<b>Company</b>	Trenz Electronic GmbH
<b>PCN Number</b>	PCN-20200616
<b>Title</b>	TE0820-03 to TE0820-04 Hardware Revision Change
<b>Subject</b>	Hardware Revision Change
<b>Issue Date</b>	2020-08-13

## 2.9 #9 LIB components update

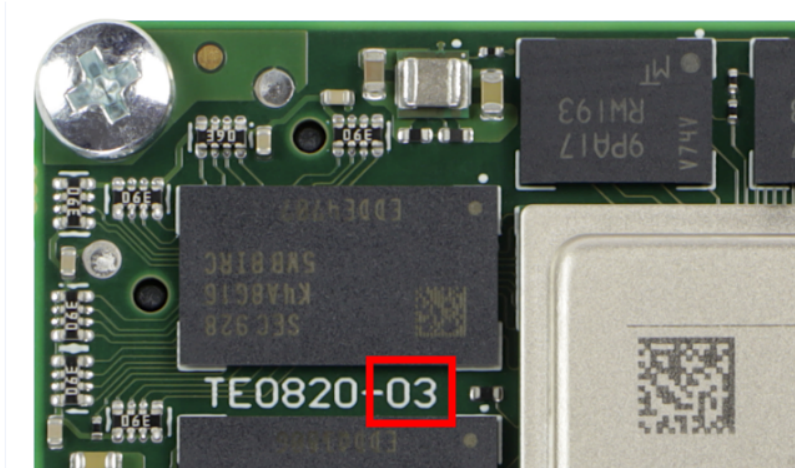
**Type:** Schematic change

**Reason:** Improve production yield.

**Impact:** None.
